Access Compliance Report Public Rights-of-Way (Curb Ramps)

Intersection ID: 53252 Main Street: MARLOWE_AV **Cross Street: FLEETWOOD DR** Location: SW **Overall Compliance: No** ADA ID: 29EF9EEBC421 Ramp Type: Perp Initial Pass/Fail: Fail Severity Score: 33.75

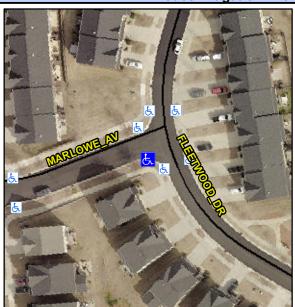
Possible Solutions:						
Remove & Replace Entire Ramp.						
Surveyor Notes:						
N/A						
DDC/WADA						
PROW/ADA:						
Not Found, R304.5.1, R304.5.3

Field Measurements/Component Compliance						
Compliance Description Data		Compliance Description		Data		
N/A	Ramp Length (in)	83.0	Yes	Ramp Slope (%)	6.3	
No	Ramp Width (in)	46.5	No	Ramp XSlope (%)	7.9	
N/A	Flare Type LT	N/A	N/A	Flare Type RT	N/A	
N/A	Flare Slope LT (%)	N/A	N/A	Flare Slope RT (%)	N/A	
N/A	Flare Traversable LT?	N/A	N/A	Flare Traversable RT?	N/A	
N/A	Landing Length (in)	N/A	N/A	DWS Provided?	N/A	
N/A	Landing Width (in)	N/A	N/A	DWS Contrast?	N/A	
N/A	Landing Slope (%)	N/A	N/A	DWS Length (in)	N/A	
N/A	Landing X Slope (%)	N/A	N/A	DWS Full Width?	N/A	
N/A	Landing Curb? (Y/N)	N/A	N/A	DWS Offset (in)	N/A	
N/A	Shared Landing?	N/A				
N/A	Gutter Ponding?	N/A	N/A	Gutter Slope (%)	N/A	
N/A	Gutter Lip Ht (in)	N/A	N/A	Gutter X Slope (%)	N/A	
N/A	Painted X Walk1?	No	N/A	Painted X Walk2?	N/A	
	X Walk 1 Direction	To N		X Walk 2 Direction	N/A	
N/A	X Walk 1 Width (in)	N/A	N/A	X Walk 2 Width (in)	N/A	
	X Walk 1 Slope (%)	1.2		X Walk 2 Slope (%)	N/A
